Gully Road Reserve

Community Consultation Findings
February 2025

This report summarises community consultation on the proposed plan for an upgrade of the open space at Gully Road Reserve, Seaview Downs.

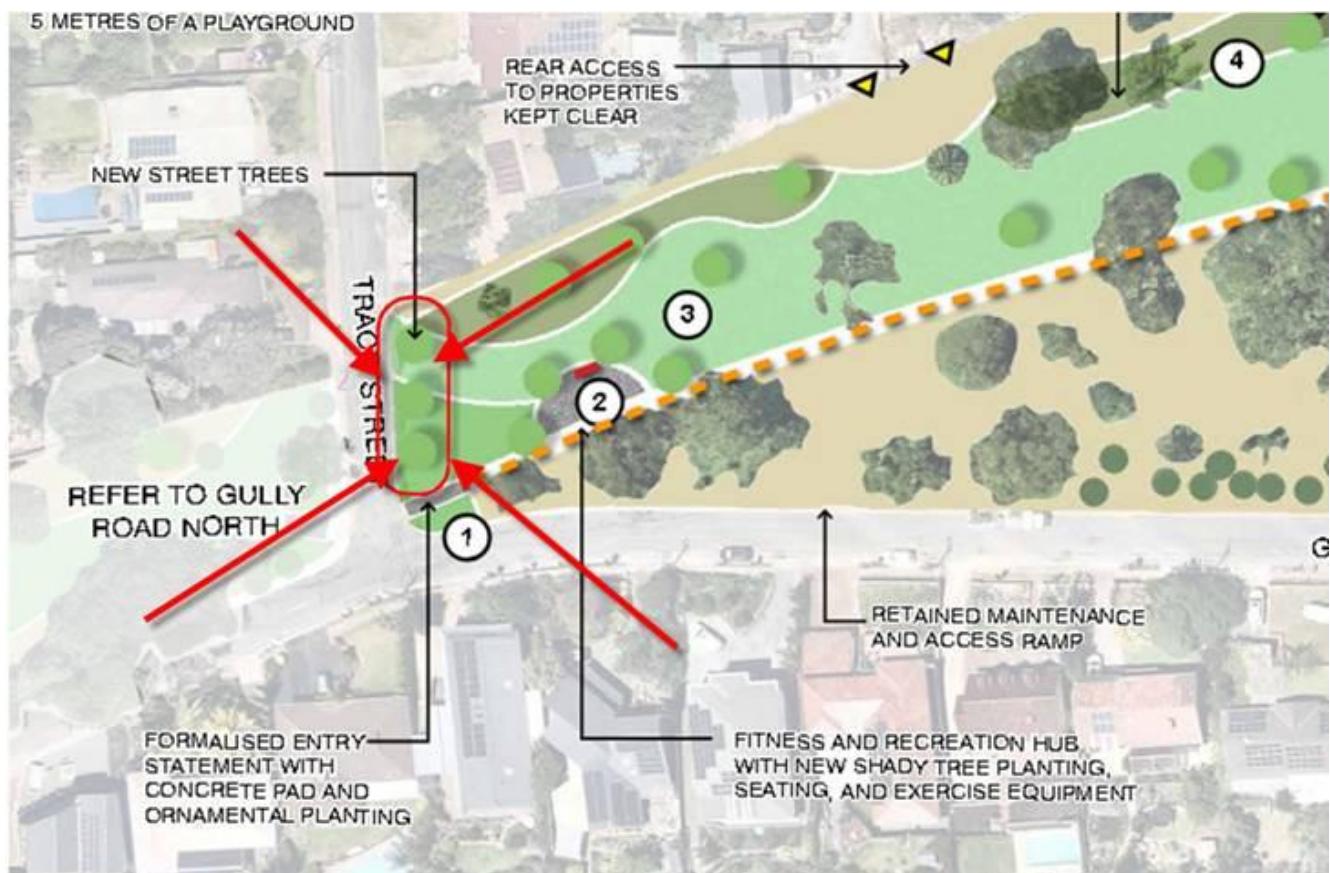
ATM, kids on mountain bikes travel along the red arrows and at speed. Note – rarely looking right (up our road Tracy Street) as they shoot across the road.

For the 1% that do bother to look and do deserve to live, the proposed trees in the section below may obscure a car driving down the hill towards them. Each careless millennial that gets wiped out will cause an increase in car insurance premiums ;)

③ SOUTHERN ENTRY STATEMENT & FITNESS AREA

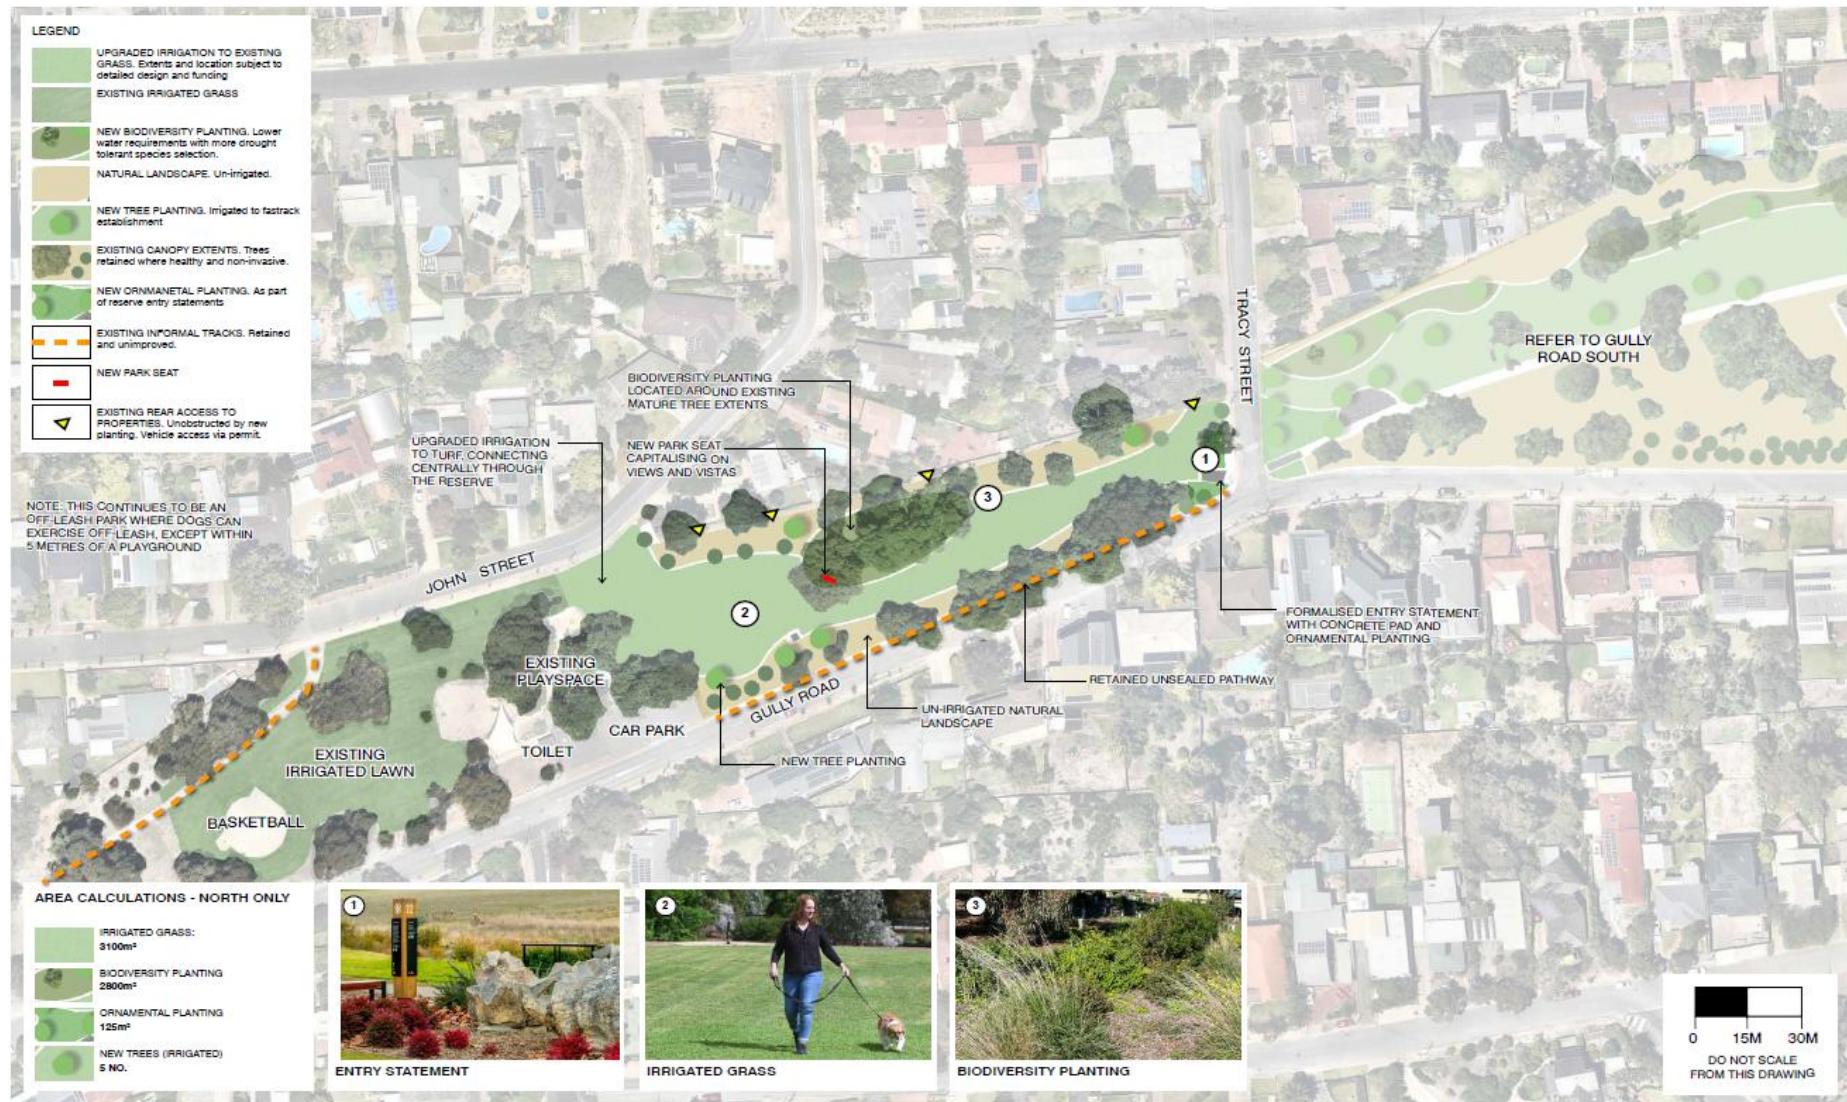
The following two pics show no measures to prevent the issue

Don't get me wrong, I actually quite prefer the above two pics as they are (without unsightly barriers). However, I wonder whether a similar barrier design to the one proposed below is also justified?

Also.... cyclists at speed colliding with peeps in the new exercise area – barriers maybe as per the two blue lines in the pic below

**GULLY ROAD RESERVE ▶ FITNESS OPTIONS**

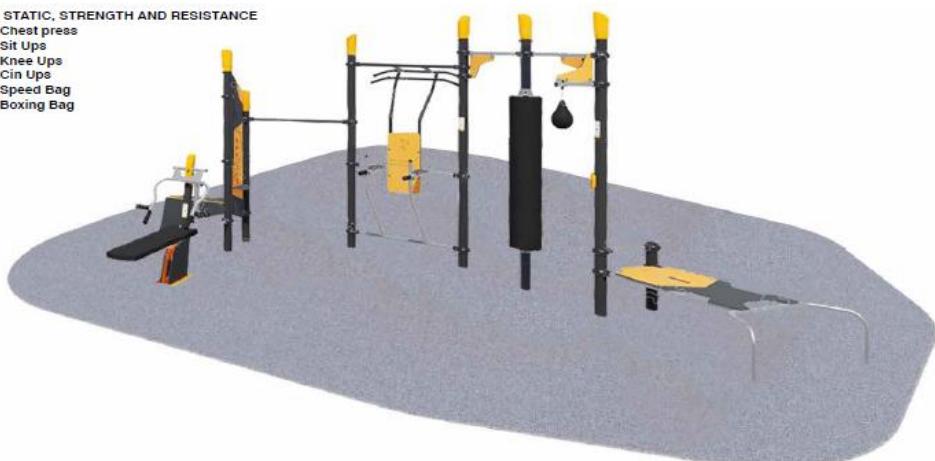
I think the resistance equipment has the ability to wear and become less useable over time. It's also limiting in what it offers for the full spectrum of fitness levels. It may be of benefit to offer a mix of option A and option C. Unfortunately option B presents it self as an opportunity for vandalism (in regard to the boxing bag and ball etc).

Option A for the fitness node would be ideal for my use and can be utilised by people with beginner to advance exercise needs. The inclusion of Box Jumps, Sit Ups, Knee Ups, Multi Bench, Chin Ups and Dips are needed to cater to my fitness category. These movements can be varied for all fitness types.

Option C would not suit those in the moderate to advanced fitness category, as the resistance is unlikely to suffice. If necessary, a hybrid could be adopted between A and C, however Option C alone would not cater to everyone's fitness needs.

Option B's boxing bag and ball are unlikely to be durable and prone to damage.

Community Feedback	Design Response
60% of survey respondents preferred Option A: Static fitness equipment	The fitness equipment chosen will be static equipment similar to Option A.
Opposed to fitness node / Move node to wider part of the reserve	The majority of respondents support the fitness node in its designed location.
Speed of cyclists is a concern	Slowing devices along the informal paths and at the fencing to Davenport Street bus stop will be explored in the design. Separation between the fitness stations and path will be designed.
Irrigation is reduced in the draft design from what is now there	Tree Protection Zones around the mature trees in the reserve, may make it difficult to replace the irrigation as it is currently. Trenching through tree roots will damage the trees and may cause tree loss. The irrigation will be designed to maximize irrigation zones.
Concern about tree planting near houses	Trees will be planted to ensure access, species suitability and consideration of resident concerns.
